Item ID: D212-664-207

Item Name: Crosstube Low Standard Aft

DRAWING NO. D212-664-247	TITLE CROSSTUBE ASS'Y (205 LOW AFT)	REV. B	<b>DART AEROSPACE LTD ENGINEERING ORDER</b>		D.E.O. NO. D212-664-247-B-1	SHEET NO. SHEET 1 OF 1	SCALE NTS
DRAWN <i>Q</i>	CHECKED <i>ASS</i>	MFG. APPR. <i>AB</i>	APPROVED <i>WD</i>		DE APPR. <i>AB</i>		
DATE 11.07.15	DATE 11.07.20	DATE 11.07.21	DATE 11/07/21		DATE 11.07.21

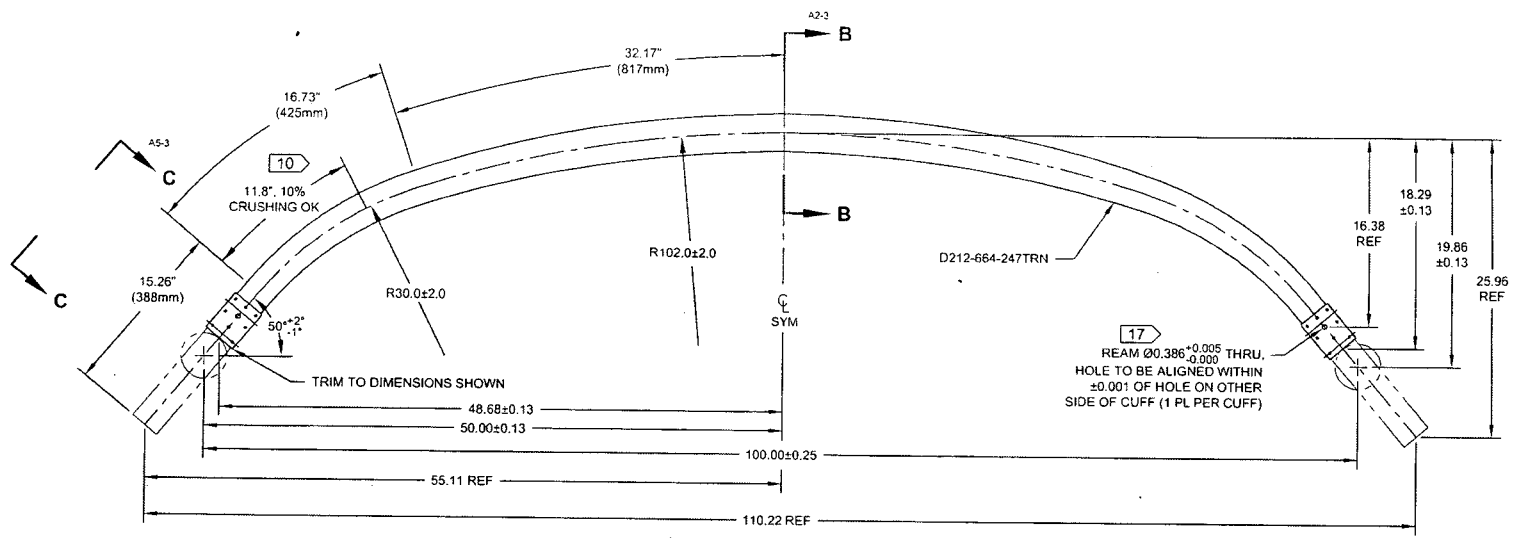
REPLACE MAGNOBOND WITH PROSEAL.

NOTE 12 & 15, SHEET 1 IS AMENDED AS FOLLOWS:

- 12) TO INSTALL D2940-1 SUPPORT: ABRASE MATING SURFACE OF SUPPORT AND CROSSTUBE WITH 180-GRIT SANDPAPER AND REMOVE RESIDUE WITH MEK (OR EQUIVALENT). APPLY A 0.04" TO 0.07" THICK LAYER OF PROSEAL 890 CLASS B-2 (OR AMS-S-8802 CLASS B-2) SEALANT TO MATING SURFACE OF SUPPORT.
- 15) TORQUE CLAMPS 80 TO 100 IN-LB. ENSURE AT LEAST 1.5 THREADS SHOWING IN SAFETY AND THAT NUT HAS NOT BOTTOMED-OUT AFTER TORQUING. **PRIOR TO PACKAGING, RE-CHECK TORQUE ON CLAMPS AFTER PROSEAL 890 SEALANT HAS CURED FOR 72 HOURS.**
